SUMMARY OF CHANGES BETWEEN CONSENTED PLANNING DRAWINGS, AS PER APPLICATION REF 126648/FO/2020 AND RESUBMITTED PROPOSED MMA APPLICATION DRAWINGS:

Project Title
T2 VITA LIVING, ST. JOHNS

Drawing Title
PROPOSED NORTH ELEVATION

Drawing Number
6555-P-B500-E-N

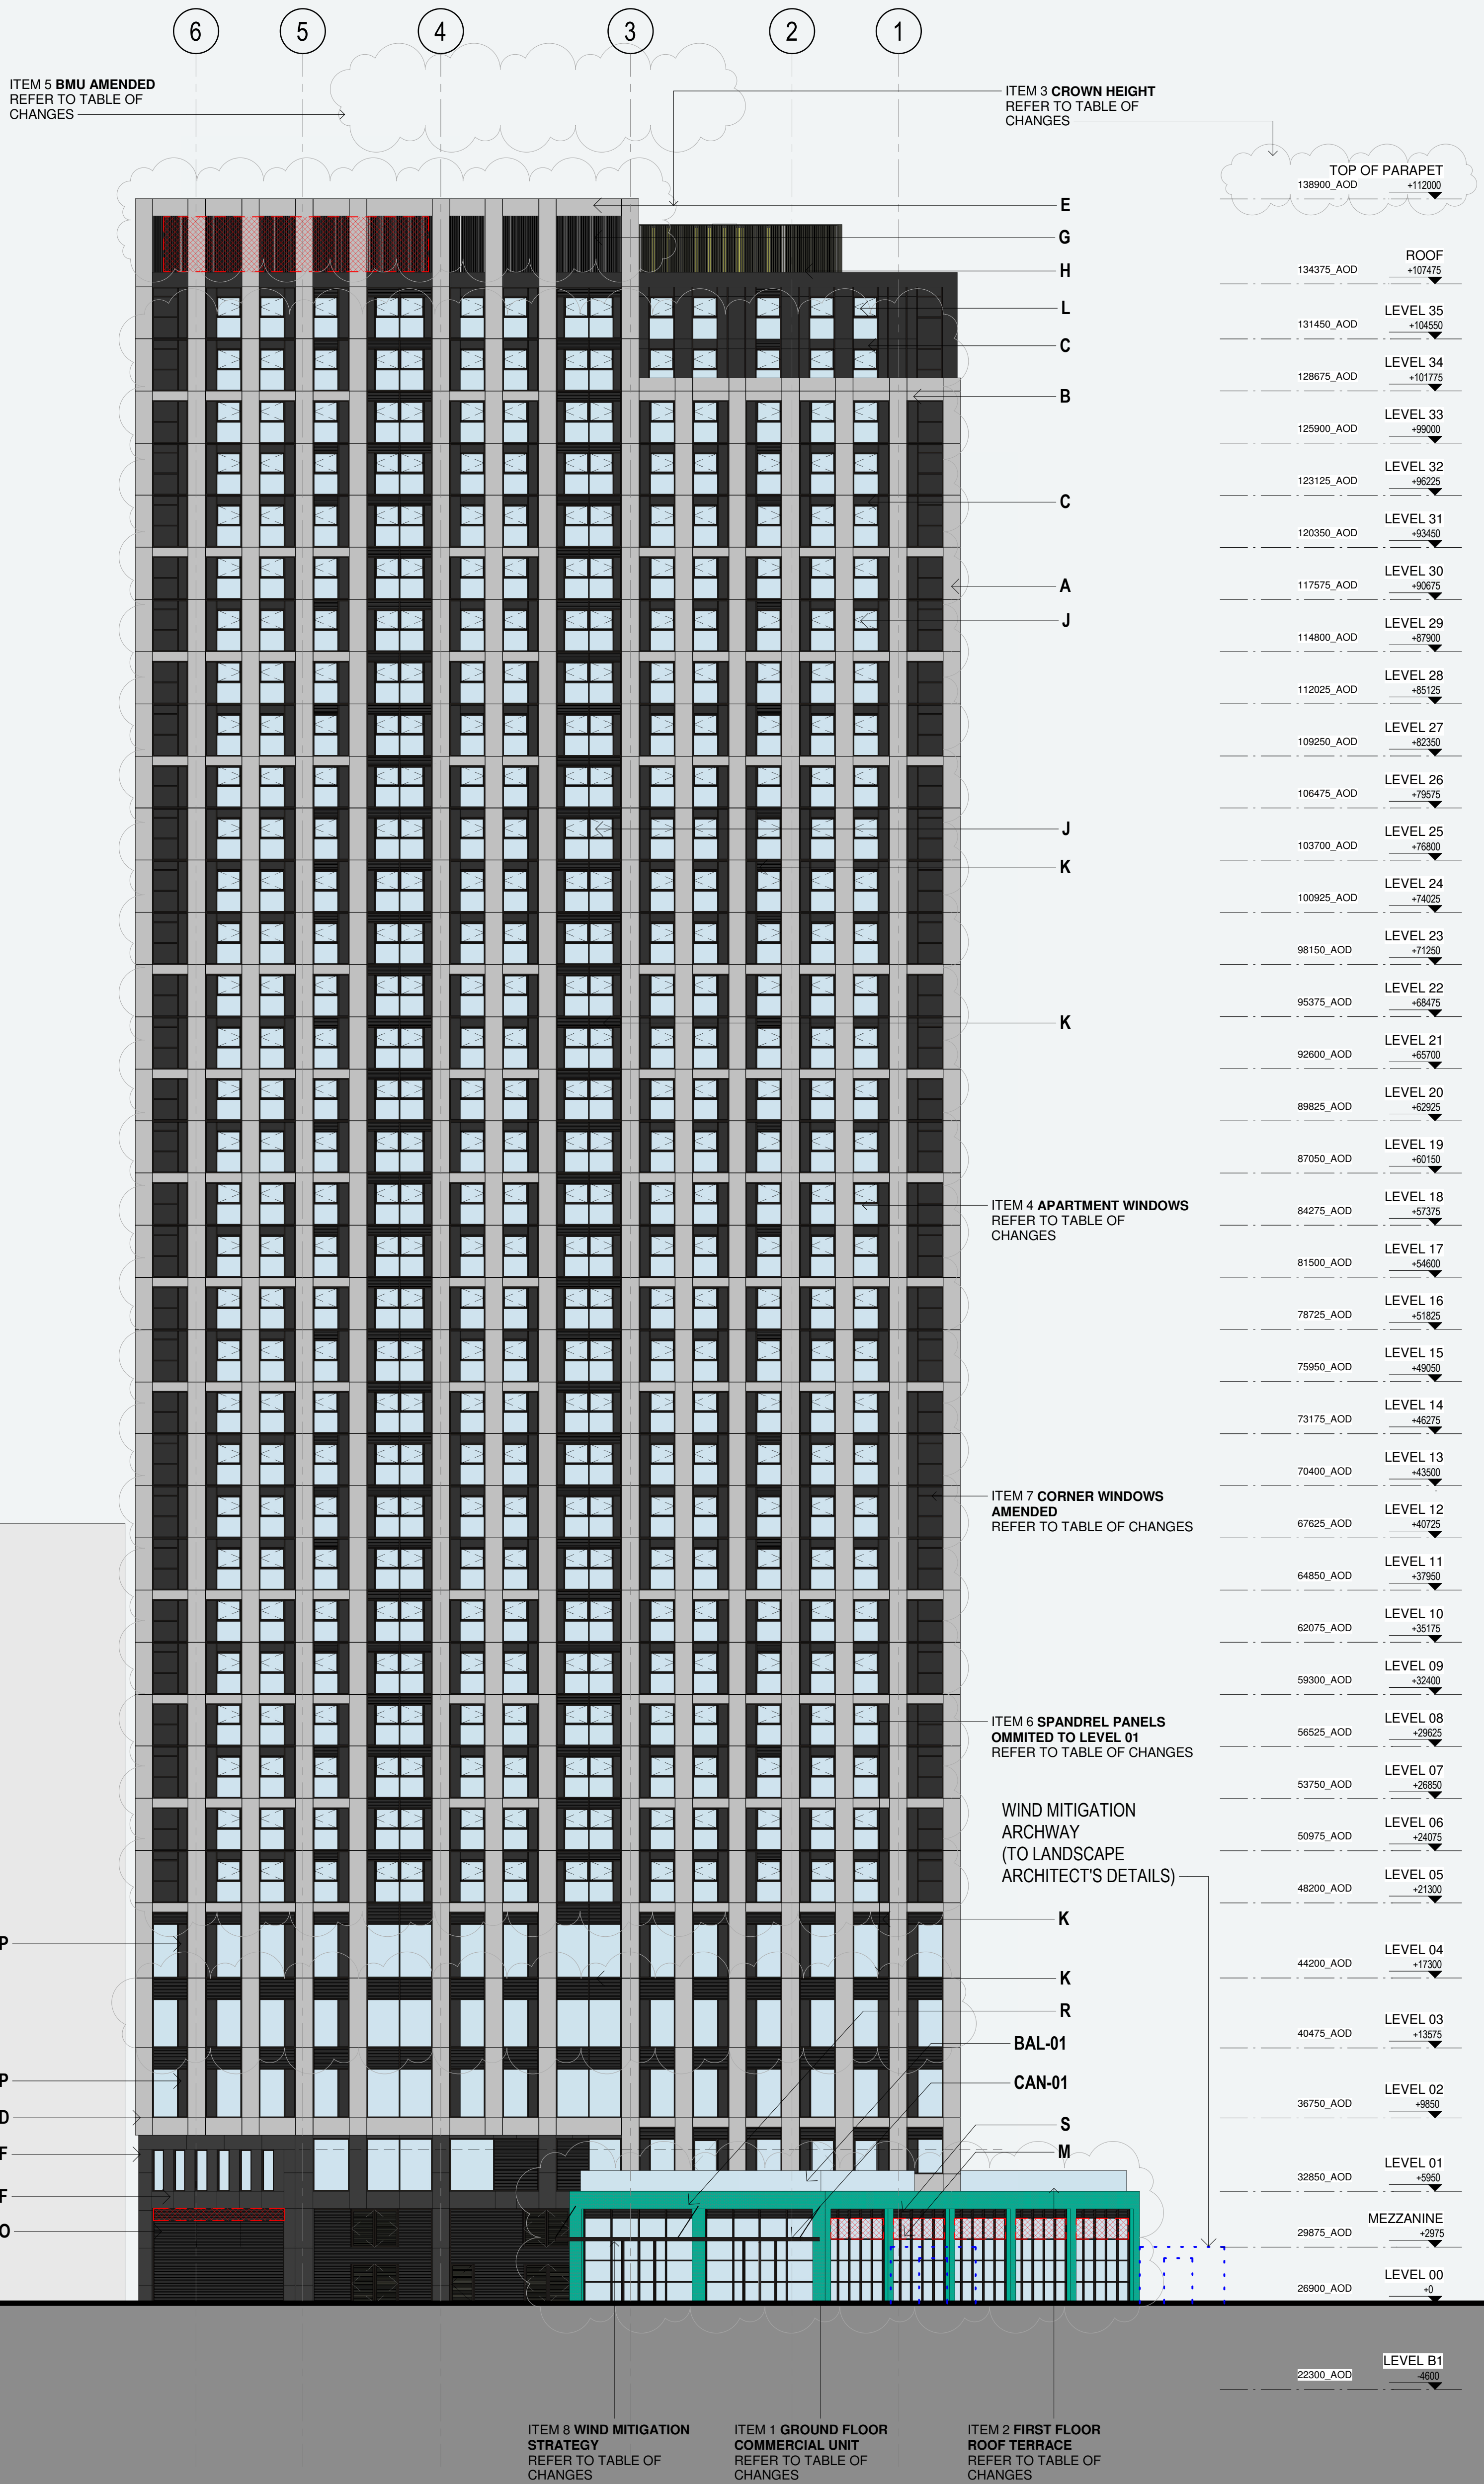
- 1 - GROUND FLOOR COMMERCIAL UNIT**
GROUND FLOOR FOOTPRINT DEVELOPED TO INCLUDE COMMERCIAL UNIT
- 2 - ROOF TERRACE**
INTRODUCED AT LEVEL 01 WITH GLAZED PERIMETER BALUSTRADE

- 3 - CROWN HEIGHT**
HEIGHT OF CROWN REDUCED BY 1.31M
OVERALL BUILDING HEIGHT REDUCED TO 112M
- 4 - APARTMENT WINDOWS**
SIZE / CONFIGURATION OF APARTMENT WINDOWS TO RESIDENTIAL FLOORS AMENDED

- 5 - BMU AMENDED**
STATIC ROOF-MOUNTED MAINTENANCE UNIT (BMU) AMENDED TO MOBILE PERIMETER TRACK-MOUNTED TYPE BMU WHICH WHEN PARKED IS FULLY CONCEALED
- 6 - SPANDREL PANELS OMITTED AT LEVEL 01-04**
FIXED GLAZED SPANDREL PANELS TO BOTTOM OF LEVEL 01/04 GLAZED SCREENS OMITTED TO NOW MAKE THE SCREENS FULL HEIGHT

- 7 - GABLE FACADE AMENDED**
SIZE AND CONFIGURATION OF WINDOWS FIXED CLEAR GLAZING AND METAL FACADE PANELS AMENDED TO ALIGN WITH SPECIALIST DESIGN ADVICE

- 8 - WIND MITIGATION STRATEGY**
ADDITIONAL TREES, CANOPY, WALKWAY ARCHES, BALUSTRADES AND SCREENS INTRODUCED FOLLOWING WIND MITIGATION ANALYSIS
